Access Compliance Report

(Curb Ramps)

Intersection ID: 21751	Main Street: BRITTON_WOOD_PL	Cross Street: POPLAR_FOREST_DR	Location: SW
ADA ID: F573AD0C01C7	Ramp Type: PerpDiag	Initial Pass/Fail: Fail	Overall Compliance: No
Severity Score: 60			
Codes/Mitigation Info/Possible Solution		Field Measurements/Component Compliance

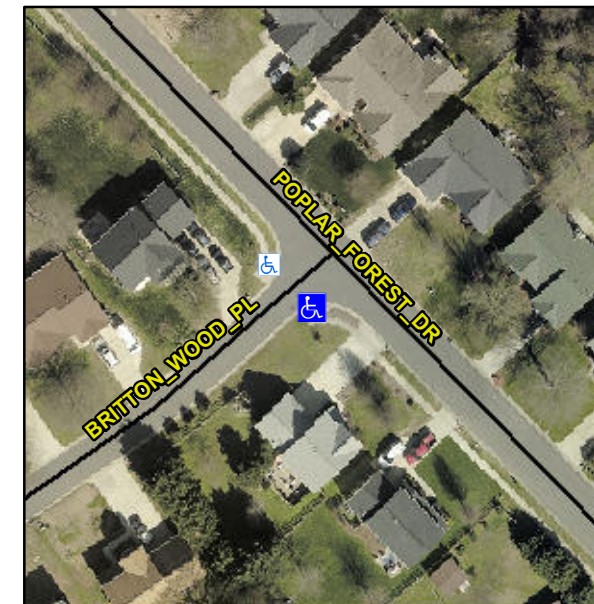
R304.5.1, R304.5.3

Compliance	Description	Data	Compliance	Description	Data
N/A	Ramp Length (in)	108.0	Yes	Ramp Slope (%)	8.1
No	Ramp Width (in)	31.0	No	Ramp XSlope (%)	7.7
N/A	Flare Type LT	N/A	N/A	Flare Type RT	N/A
N/A	Flare Slope LT (%)	N/A	N/A	Flare Slope RT (%)	N/A
N/A	Flare Traversable LT?	N/A	N/A	Flare Traversable RT?	N/A
N/A	Landing Length (in)	N/A	N/A	DWS Provided?	N/A
N/A	Landing Width (in)	N/A	N/A	DWS Contrast?	N/A
N/A	Landing Slope (%)	N/A	N/A	DWS Length (in)	N/A
N/A	Landing X Slope (%)	N/A	N/A	DWS Full Width?	N/A
N/A	Landing Curb? (Y/N)	N/A	N/A	DWS Offset (in)	N/A
N/A	Shared Landing?	N/A			
N/A	Gutter Ponding?	N/A	N/A	Gutter Slope (%)	N/A
N/A	Gutter Lip Ht (in)	N/A	N/A	Gutter X Slope (%)	N/A
N/A	Painted X Walk1?	No	N/A	Painted X Walk2?	No
	X Walk 1 Direction	To NE		X Walk 2 Direction	To NW
N/A	X Walk 1 Width (in)	N/A	N/A	X Walk 2 Width (in)	N/A
	X Walk 1 Slope (%)	5.3		X Walk 2 Slope (%)	0.7
	X Walk 1 X Slope (%)	0.9		X Walk 2 X Slope (%)	5.9

Remove & Replace Curb Ramp With Two New Directional Ramps or Equivalent.
